LiDAR Quality Assessment Report

UT_FEMAHQ_B2_QL1_2018

Project: UT_FEMAHQ_B2_QL1_2018

This report is for Block 2 QL1 only.

Checkpoint Distribution Image

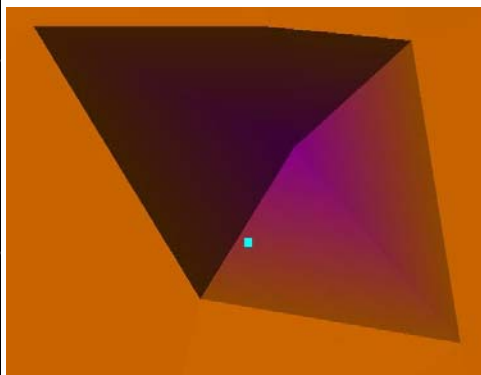
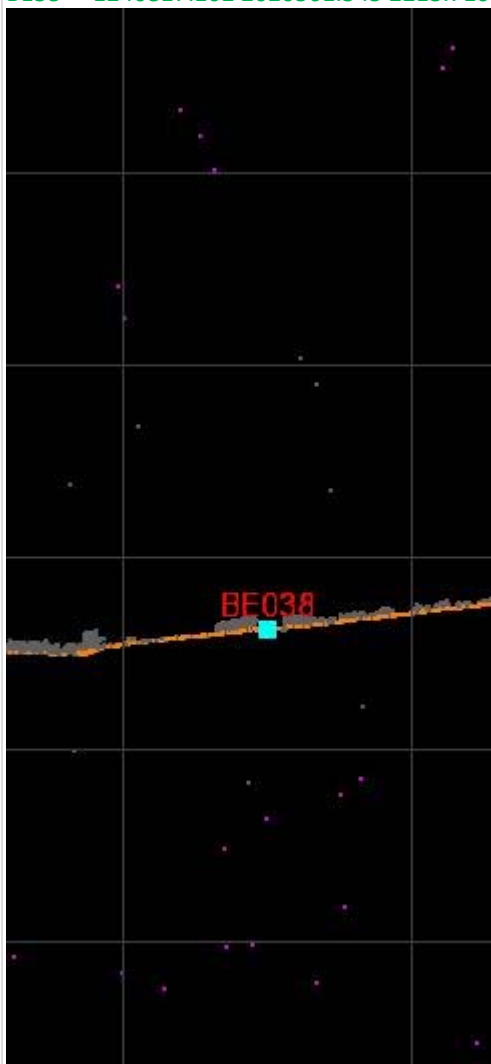
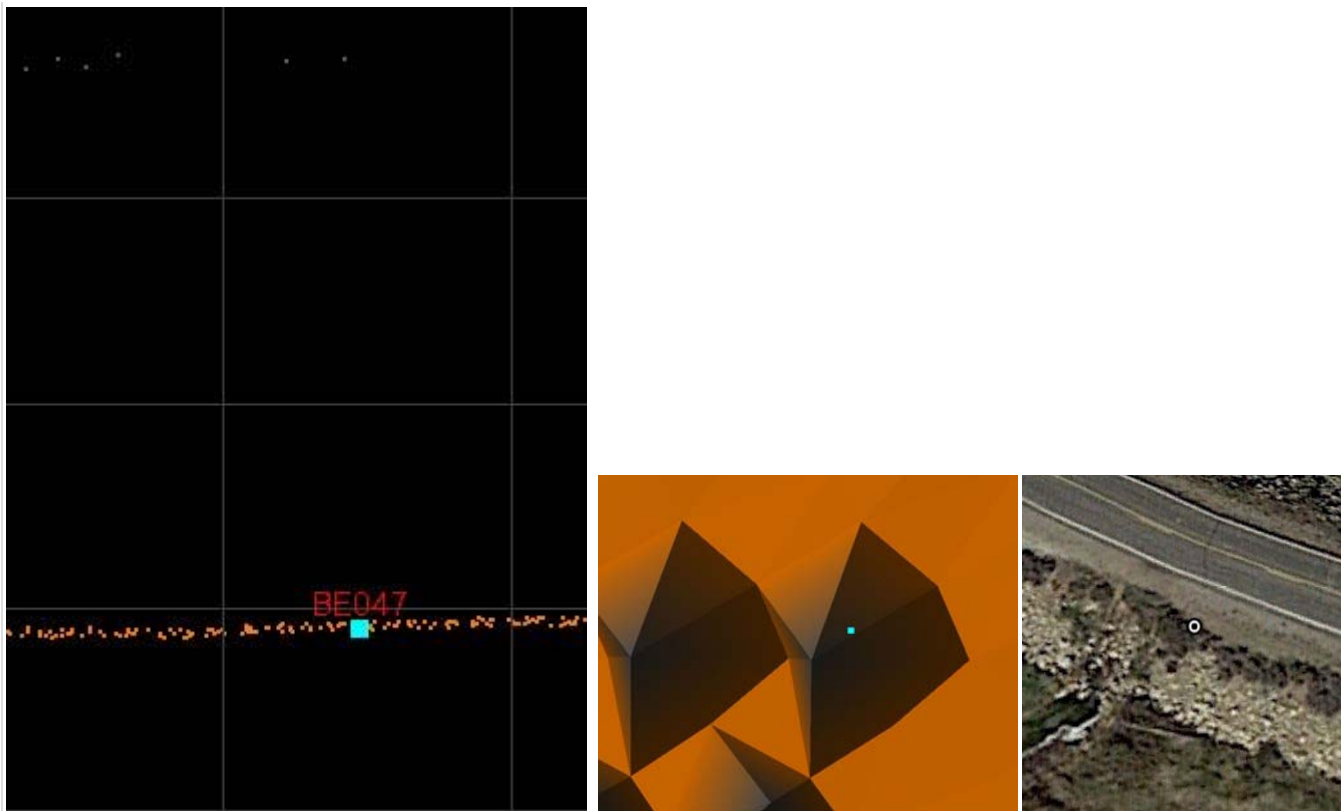
Corrected 5/15/2019 - Points removed from analysis by contractor

- BE38 and BE47 have a DeltaZ over 6.

BE38 -1246817.102 2020561.545 2213.710 2190.125 Control 23.585

BE47 -1212071.899 2009534.697 1788.150 1794.571 Control -6.421

If BE47 (zDiff = -6.421) is removed, the VA fails (RMSEz = 218.07 cm).

If BE38 (zDiff = 35.828) is removed, the VA fails (RMSEz = 58.0 cm).

If both BE38 and BE47 are removed, the VA passes (RMSEz = 3.3 cm).

Based on this review, the USGS accepts the vertical accuracy.

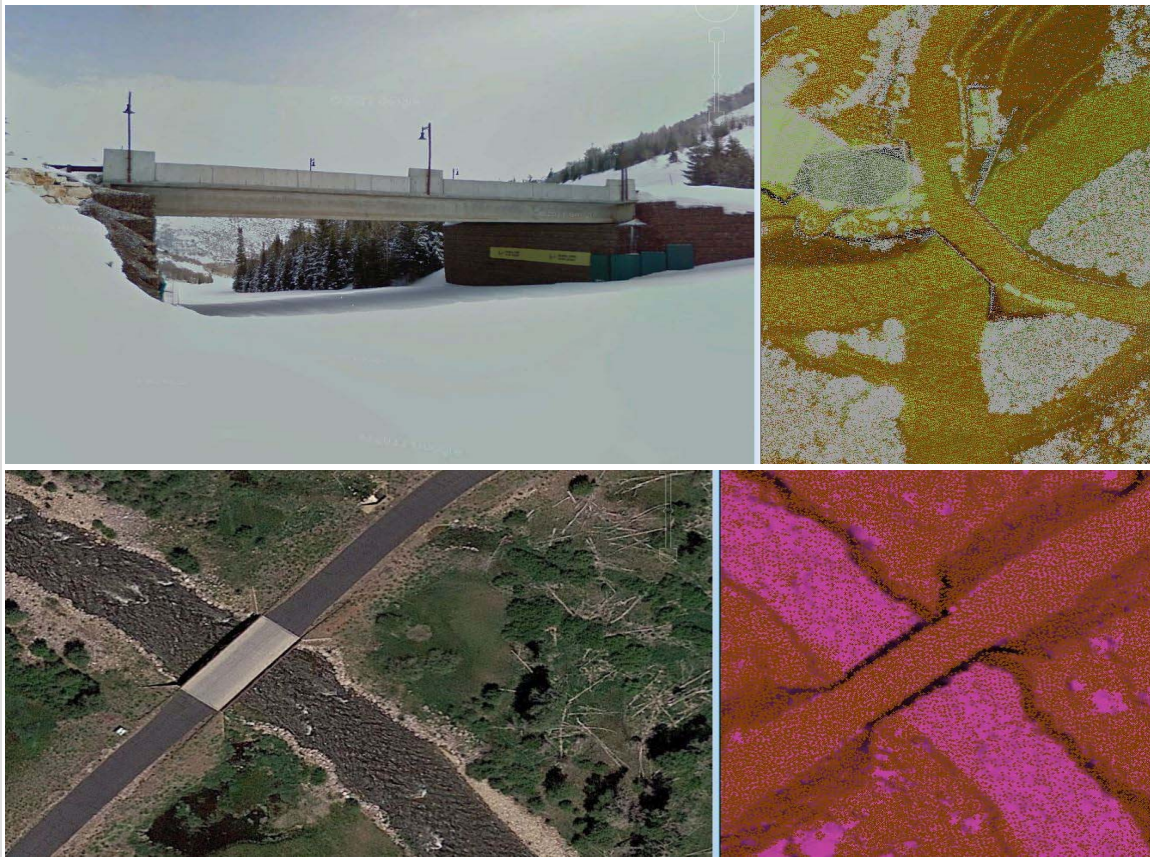
- Las Files have classifications of 10 (1 Las tile), 11 (926 Las tiles), and 14(13 Las tiles). Project Report and Metadata XML's do not contain those classifications.

Corrected 5/14/2019

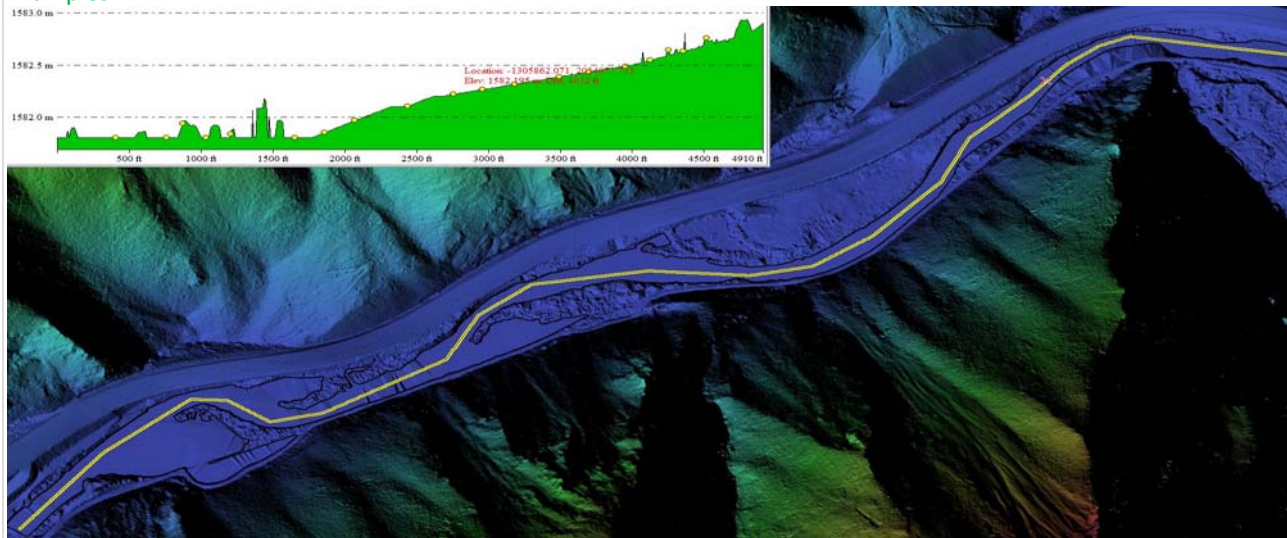
- 4 Bridge areas with points not classified correctly, causing bridges to be left in DEM, see UT_FEMAHQ_B2_QL1_Errors and UT_FEMAHQ_B2_QL2_Errors error shapefiles.

Corrected 5/14/2019

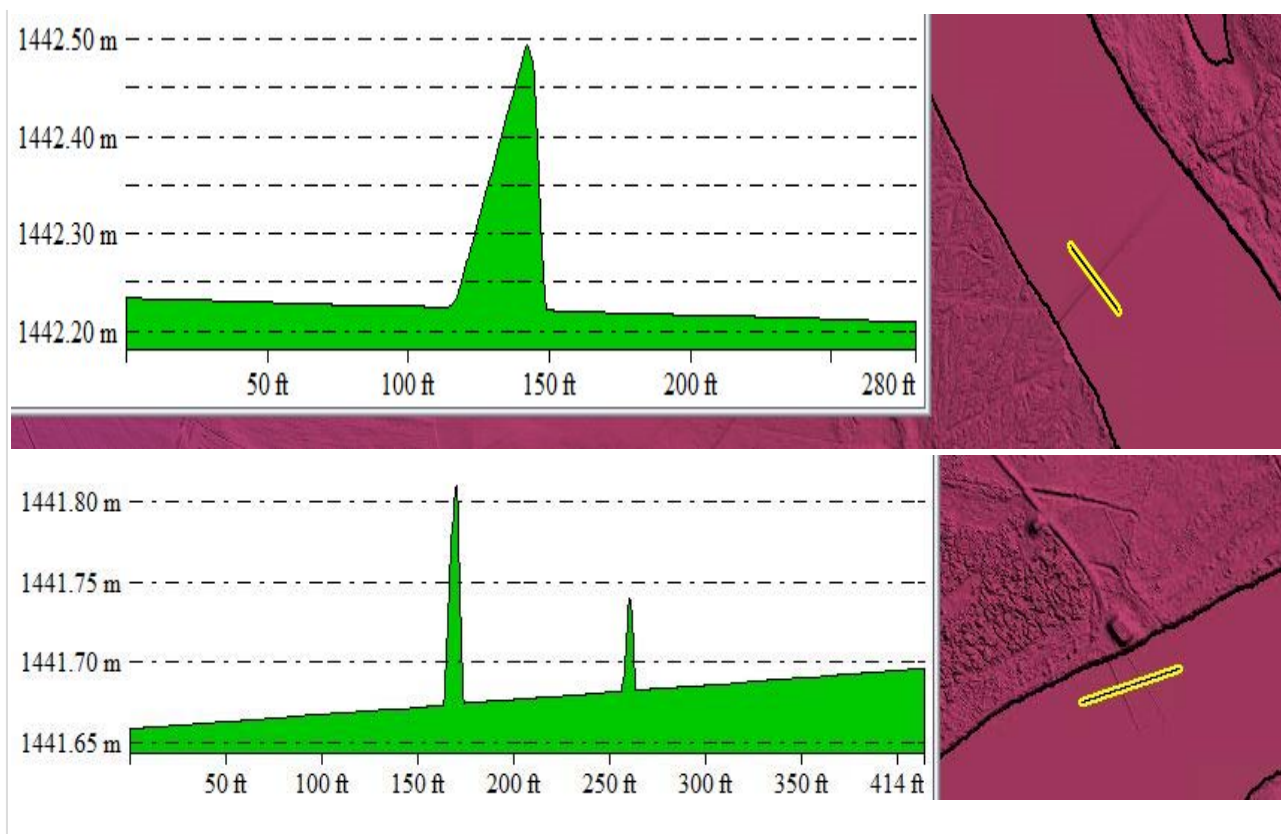
- 2 Culvert areas with points not classified correctly, causing culverts to be removed from DEM, see UT_FEMAHQ_B2_QL1_Errors error shapefiles.

Corrected 5/14/2019
